CONVERTING THE FD-68 RGB FOR POSITIVE SYNC MONITORS

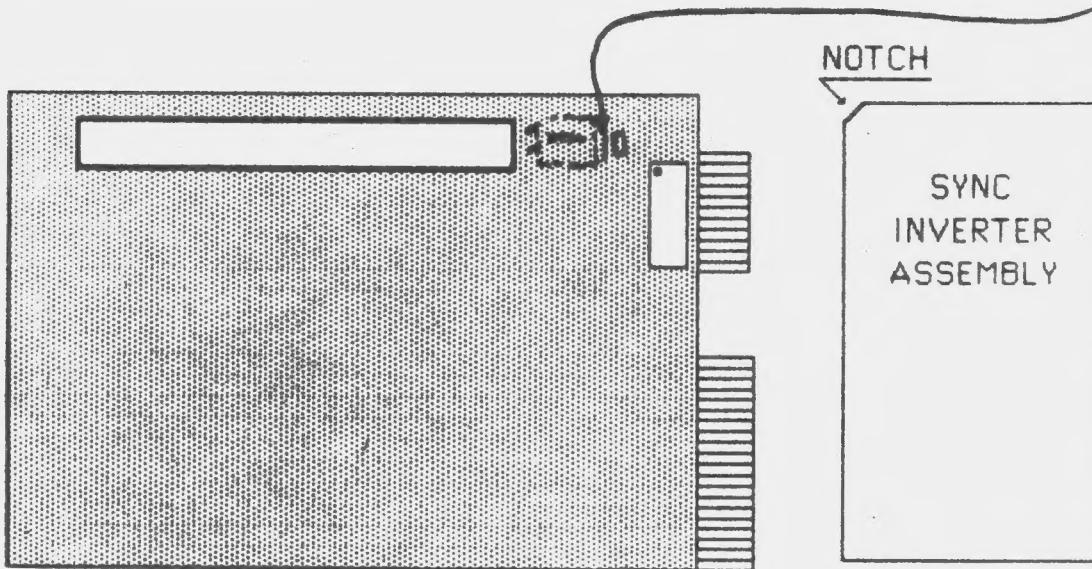
P.S. - Possible the PL monitor will jitter -
try changing the 100K Ω resistor here to $\approx 39K \Omega$

REMOVE THE LS-367 AND REPLACE WITH
THE ENCLOSED ASSEMBLY.

INSERT ASSEMBLY WITH THE NOTCH AT
THE SAME CORNER AS THE DOT. IF YOU
RE-INSTALL THE LS-367, BE SURE TO
PLACE IT IN THE SAME DIRECTION.
